## ***Interactive comment on “Simulation of storm surge inundation under different typhoon intensity scenarios: Case study of Pingyang County, China” by Xianwu Shi et al.***

Interactive comment on Nat. Hazards Earth Syst. Sci. Discuss., <https://doi.org/10.5194/nhess-2019-425>, 2020.

**Fig. 1.** The relation between the central pressure difference ( $\Delta P$ ) and the radius of maximum wind ( $R_{max}$ )

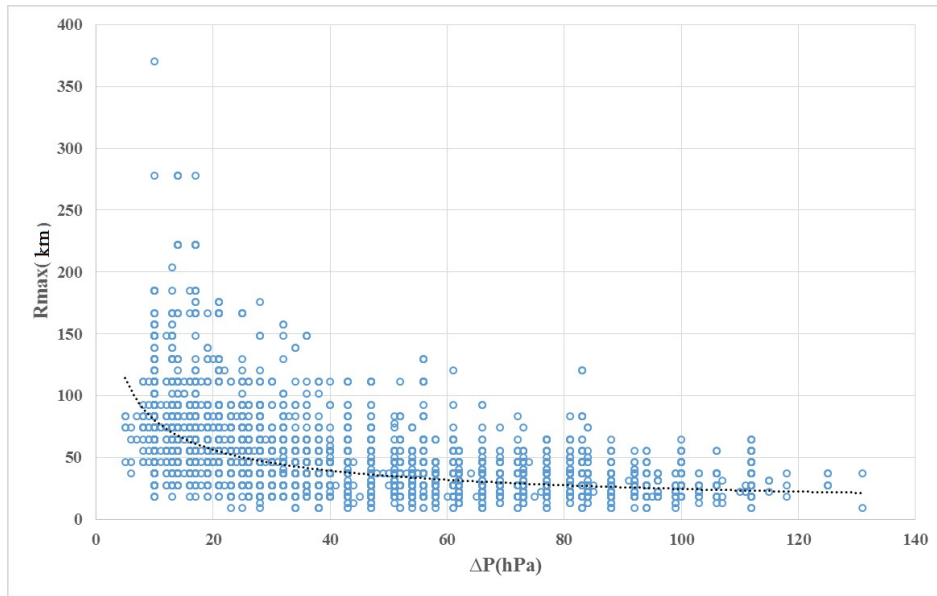
3. Additionally, the typhoon size is inversely proportional to the typhoon intensity if the Jelesnianski typhoon model was used. This phenomenon should be discussed in the manuscript. Response: Thanks for your suggestion. The typhoon size has a strong connection to the typhoon intensity. As described above, radius of maximum wind speed was used to indicate the “size” of the typhoon. Collecting the historical radius of maximum wind speed data measured in the northwest Pacific hurricane records (2001-2016) from the Joint Typhoon Warning Center (Wang et al, 2020), it can be seen that the radius of maximum wind speed is inversely proportional to the central pressure difference. In this study, the empirical relationship below was used to calculate the value of Rmax:  $R=R_0 - 0.4(P_0 - 900) + 0.01(P_0 - 900)^2$  where  $P_0$  is the central air pressure (hPa),  $R$  is the radius of maximum wind speed, and  $R_0$  is
